TECHNICAL SERVICE BULLETIN

TC07 Turf Cutter

14 August 2008 (rev. 5 March 2009)

DISENGAGED LUBRICATE

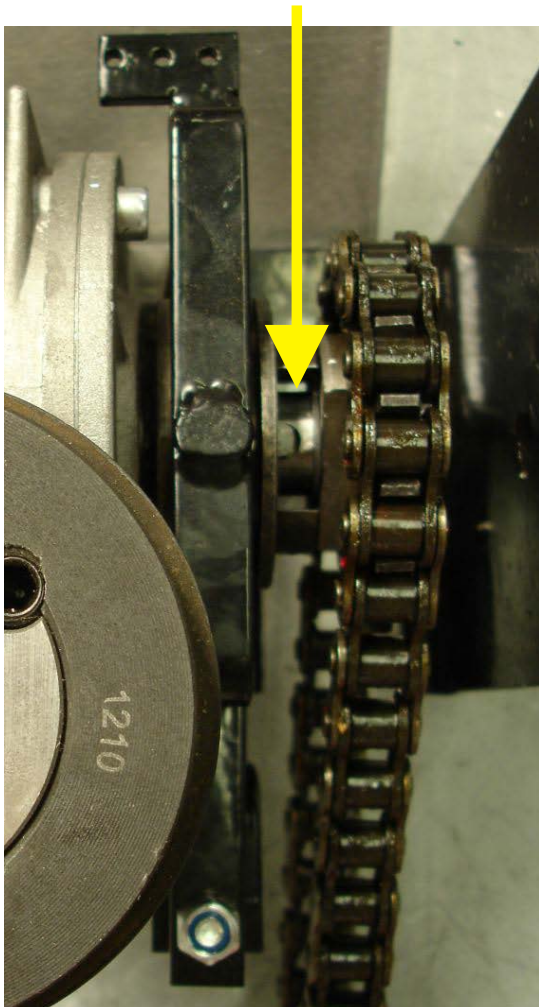
- PROBLEM:** Unable to engage or disengage drive to rear wheels.
- POSSIBLE CAUSE:** Pressure washing has removed the lubricant from the clutch system.
- SOLUTION:** Lubricate the sliding clutch, shaft and chain with light oil or penetrating fluid. the clutch system should be lubricated weekly and before storage.
- NOTE - PRESSURE WASHING THE TRANSMISSION ASSEMBLY SHOULD BE AVOIDED.**
